# UNITED STATES PATENT AND TRADEMARK OFFICE

APPLICATION NO.	FILING DATE	FIRST NAMED INVENTOR	ATTORNEY DOCKET NO.	CONFIRMATION NO.
10/765,958	01/29/2004	Hiroshi Takeuchi	MIT-024-USA-P	2329

**Office Action Summary**

### **DETAILED ACTION**

Figure A

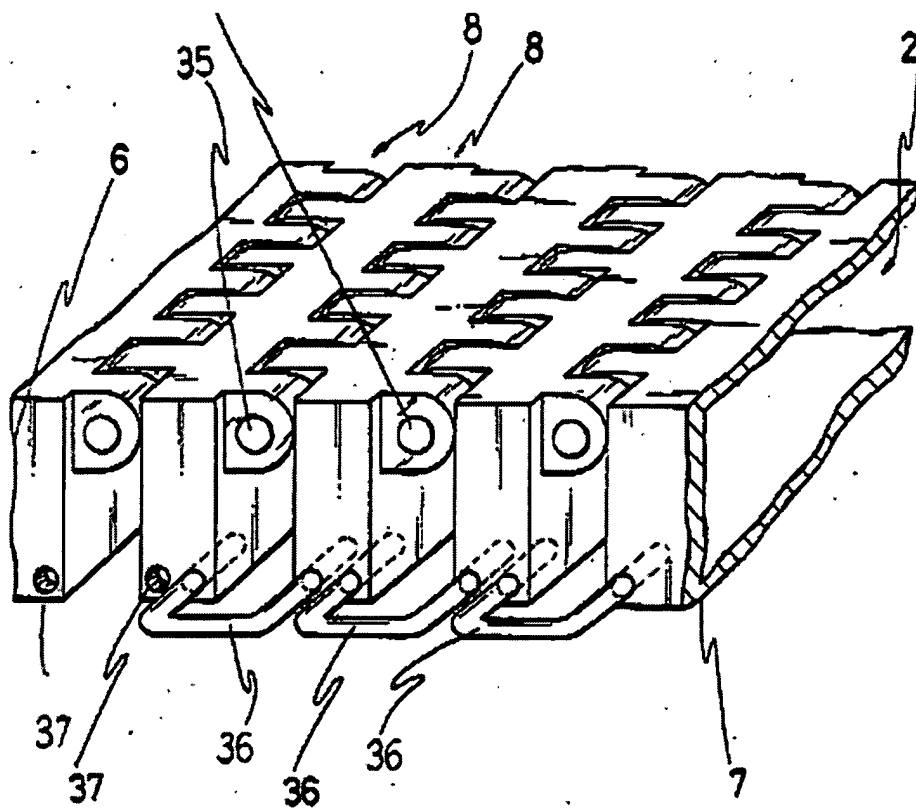
FIGURE A better shows the cited structures of TORAN and is depicted below. While TORAN

As to claim 3, TORAN discloses first beveled portions are formed on lower sides at the tips of the connecting protrusions while second beveled portions are formed on the upper sides at the bases of protrusions, to use the bendable bottom member as a bendable portion between the back region and the waist region. See FIGURE A above.

As to claim 4, TORAN discloses first beveled portions are formed on the upper sides at tips of connecting protrusions, while second beveled portions are formed on lower sides at the bases of protrusions, to use the bendable bottom member as a bendable portion between the waist region and the leg region. See FIGURE A above, but reverse the labels of first and second beveled portions. Claims 3 and 4 are not interdependent and so the alternative interpretations are valid.

As to claim 5, TORAN discloses the second beveled portions at the bases of the connecting protrusions are inclined in adaptation to the desired bending angles with the adjacent bars. See FIGURE A above.
